SUTTON CONSERVATION COMMISSION

June 4, 2014

MINUTES

REVISED EMBANKMENT REPAIR SKETCH

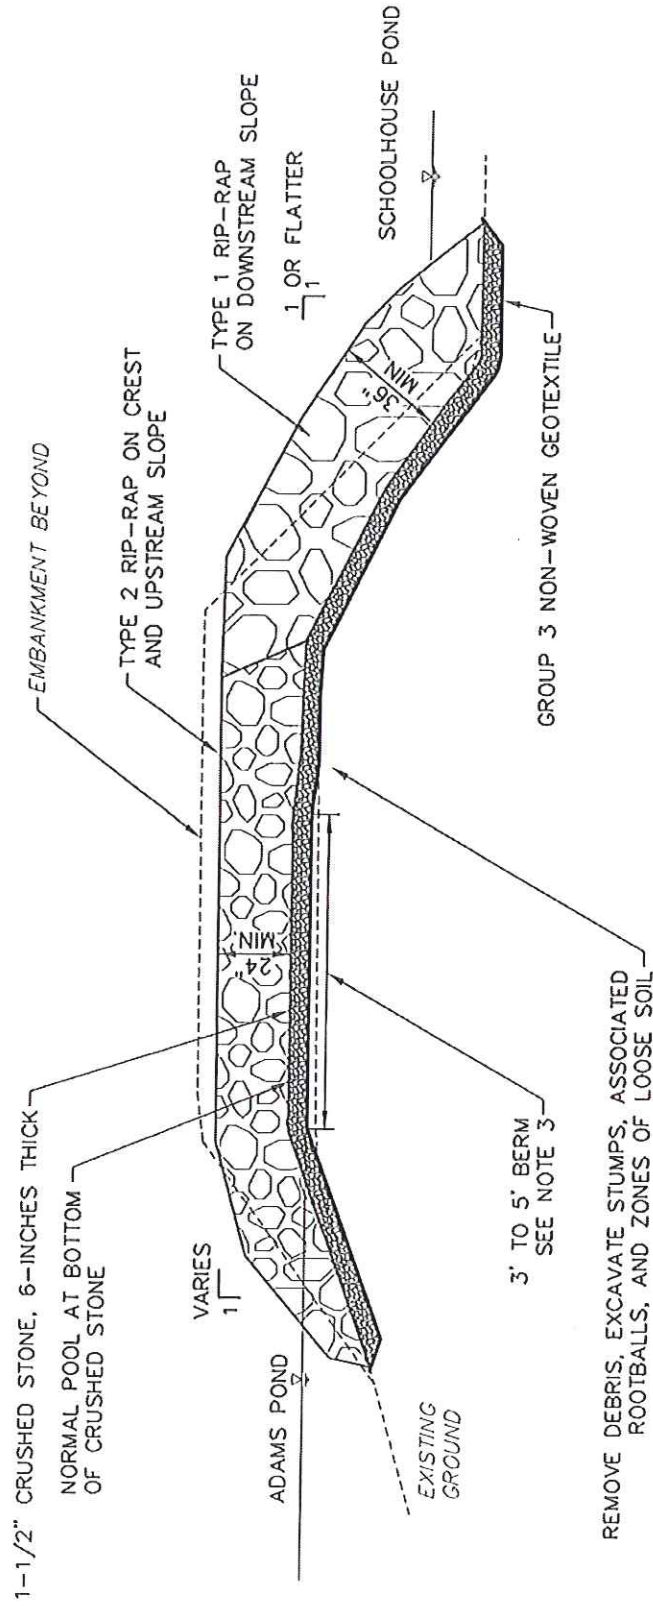
As you may know, Tighe & Bond has developed a design modification for the repair of the Adams Pond Dam embankment. The modification includes armoring the existing eroded areas of the embankment on either side of the existing spillway in lieu of filling these areas to match the surrounding crest elevation. These areas have eroded over time likely due to historic overtopping events, which suggests the spillway is undersized.

Armoring these areas instead of filling them allows flows through these areas to supplement the spillway's hydraulic capacity with reduced risk of a breach due to erosion. Supplementing the spillway's hydraulic capacity reduces the risk of overtopping the remainder of embankment during storm events that could also lead to an uncontrolled breach.

The armoring consists of placement of a geotextile, followed by 6-inches of crushed stone, and two feet of rip-rap. Prior to placement of the geotextile, the woody debris that is partially maintaining the impoundment elevation will be removed and supplemental fill will be placed to raise the subgrade.

To allay concerns regarding future water levels, the subgrade below the 1-1/2" crushed stone layer will be raised to the elevation of the concrete cross beams within the outlet structure. During the past few weeks, the water level has been generally observed to be within 2 inches of those cross beams. A cross section of the proposed changes is shown on the attached sketch. As-built plans will be prepared at the completion of the project.
